From: Mark Reynolds <mark.reynolds@cwmining.com>
To: Steve Christensen <stevechristensen@utah.gov>, Jim Smith <jimsmith@utah.gov>, Joe Helfrich <joe Helfrich@utah.gov>, Wayne Hedberg <waynehedberg@utah.gov>, Dale Harber <dharber@fs.fed.us>, Karl M Boyer <kboyer@fs.fed.us>
Date: 2/9/2007 12:40:26 PM
Subject: Bear Canyon PHC

Attached are the pages and maps that were changed as per the telephone conversation this morning. I will deliver a hard copy of these pages and maps to the PFO and the FS this afternoon. I will deliver a hard copy of these pages and maps along with cd that contain the entire amendment with these pages included to the DOGM Salt Lake office Monday. Below is a summary of the changes.

Probable Hydrologic Consequences of Coal Mining in the Mohrland Permit Area

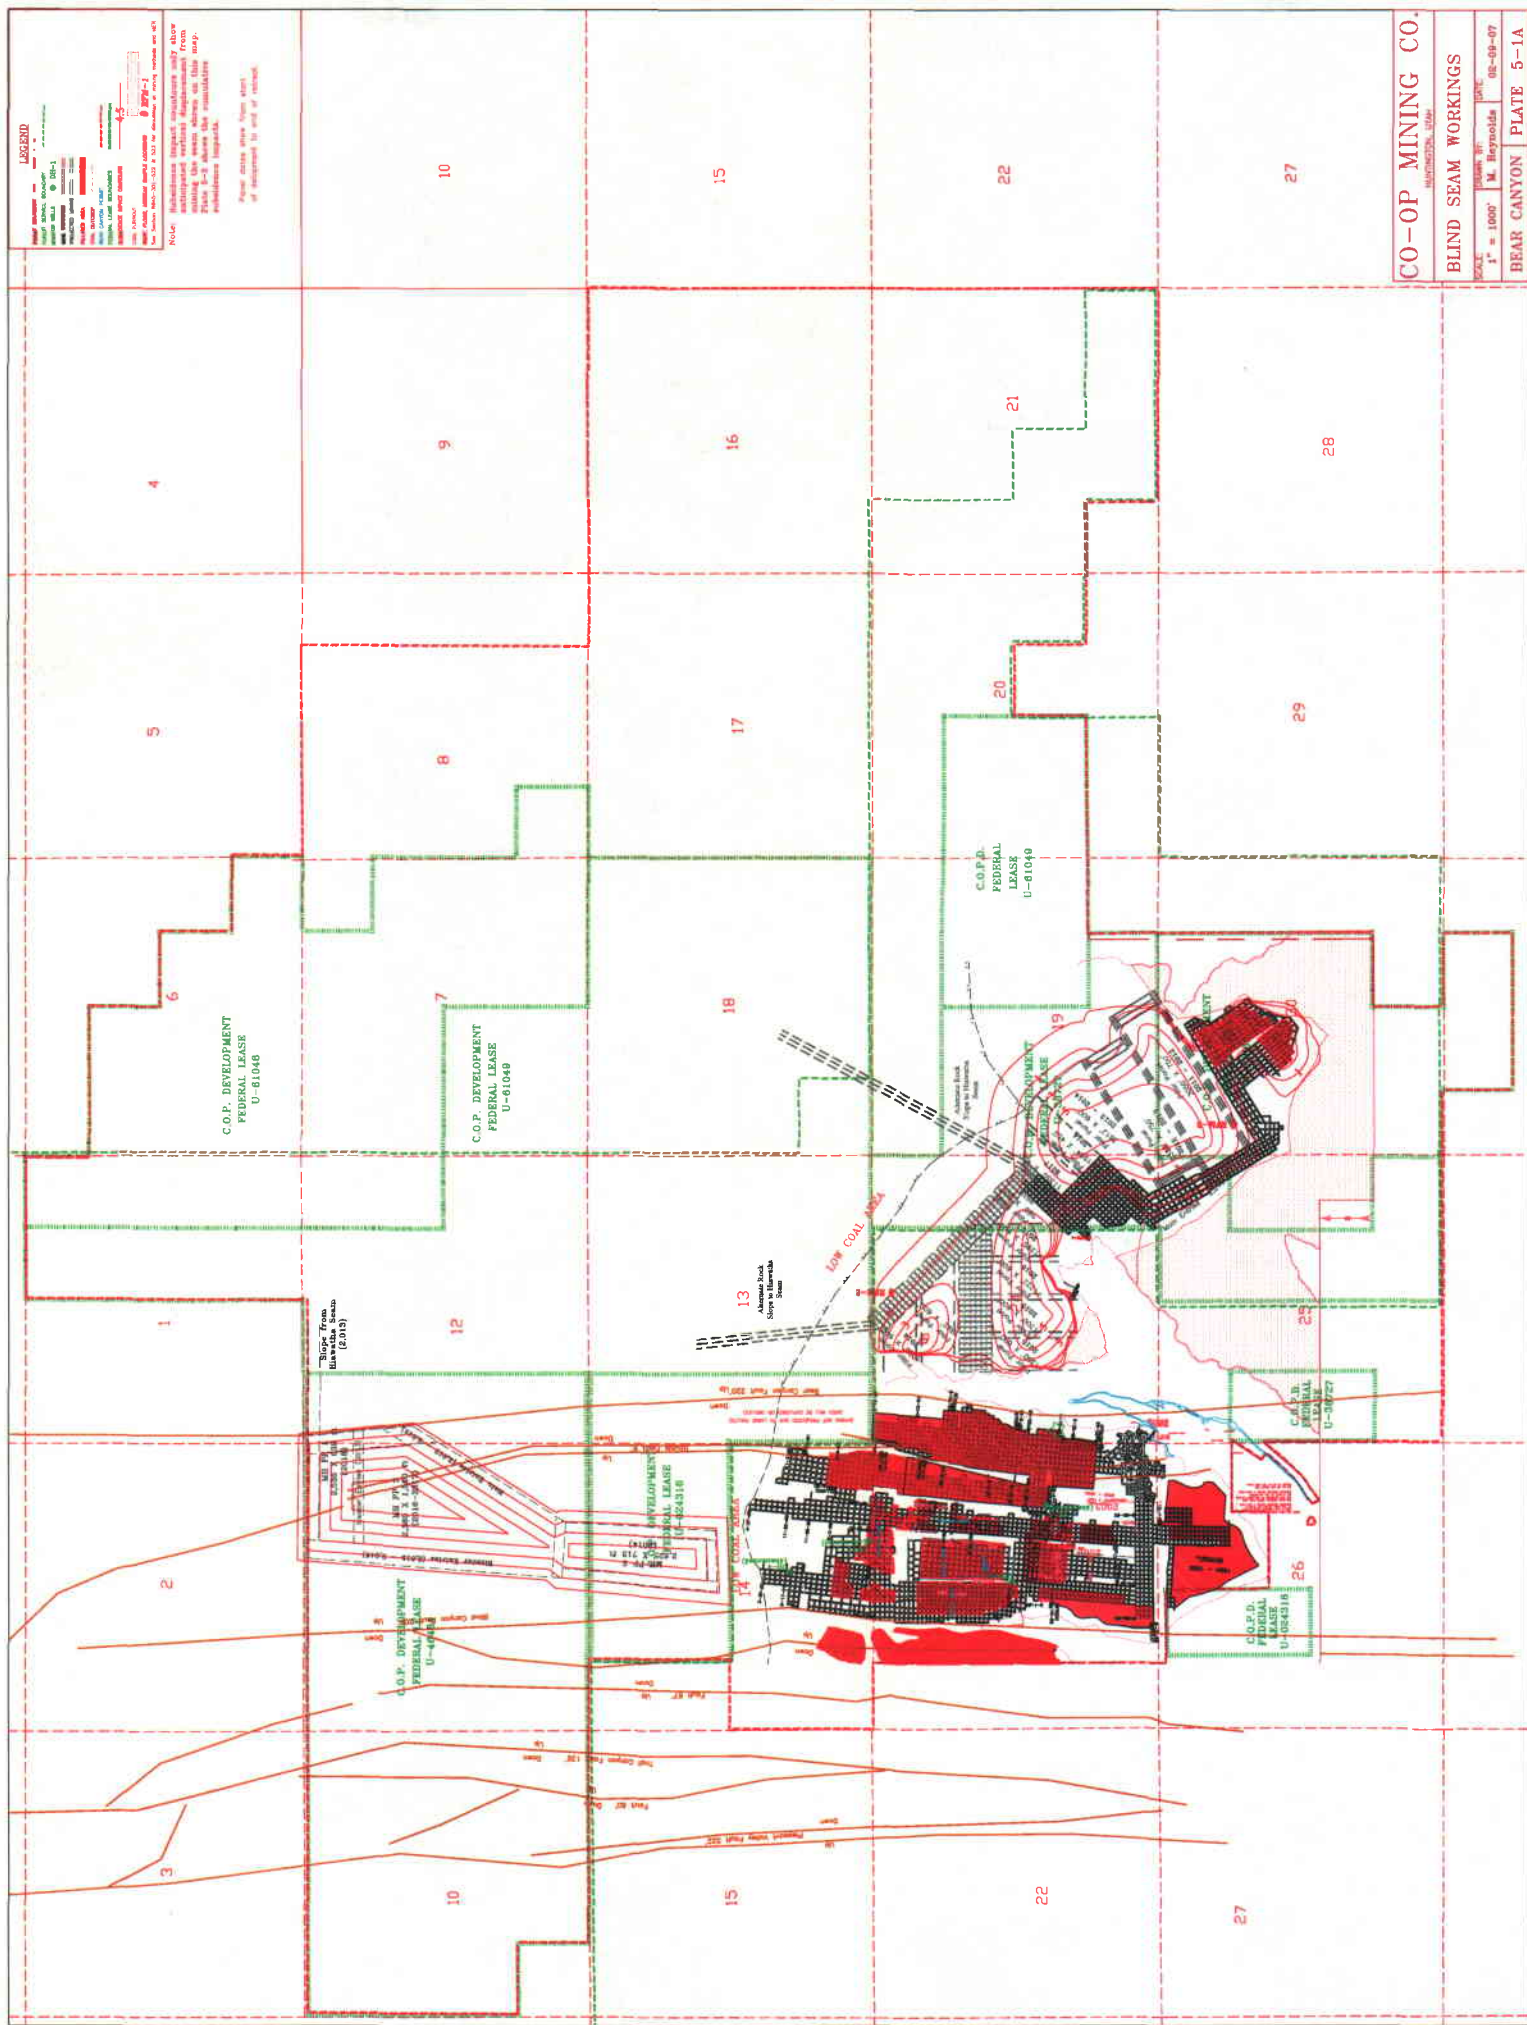
Page 1-6. Changed the property descriptions in accordance with the comments from Joe and Wayne.
